**SUBJECT: Addendum No. 2**  
**El Dorado Trail Improvement Project, Forni Road to Missouri Flat Road**  
**(Bid # GS 08-1021)**

**EL DORADO TRAIL IMPROVEMENT PROJECT  
FORNI ROAD TO MISSOURI FLAT ROAD**

**ADDENDUM No. 2 - EXHIBIT "2"**

**SECTION A-A**

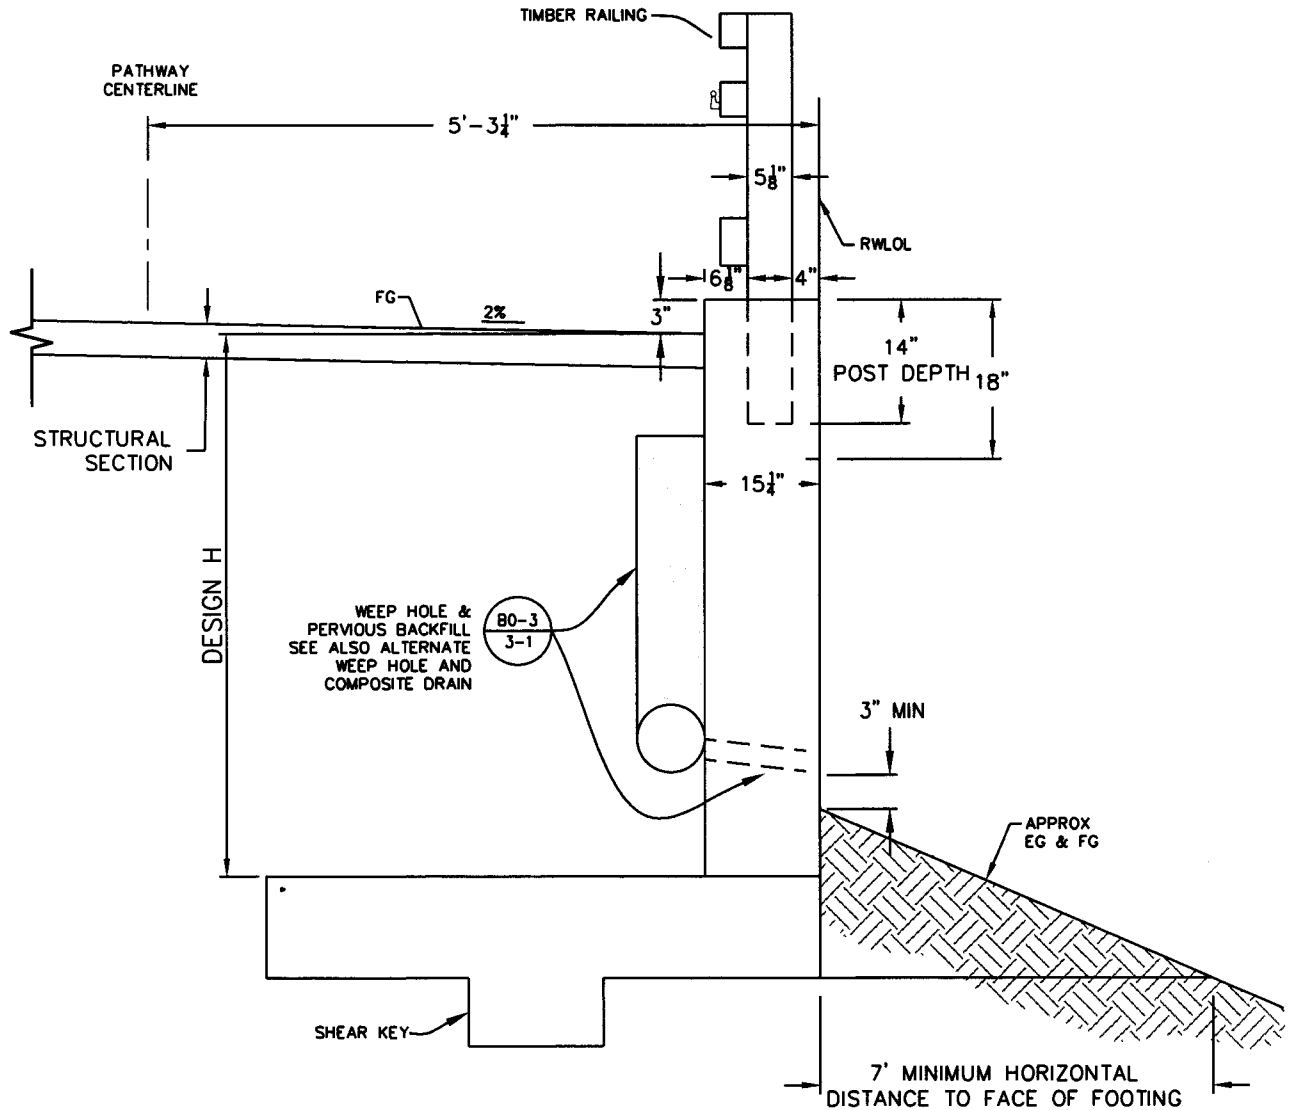
2.21	Plan Sheet C19	<b>SECTION A-A</b> Replace "Section A-A" detail with "Exhibit 2" attached.
2.22	Plan Sheet C19	<b>RETAINING WALL PLAN VIEW STA 33+40.00 TO STA 34+12.00</b> <b>RETAINING WALL PLAN VIEW STA 35+50.00 TO STA 37+54.00</b> Replace RWLOL dimension "4-11 1/2'" with "5-3 1/4'"

Exhibit 2: Replaces Section A-A on Plan Sheet C-19
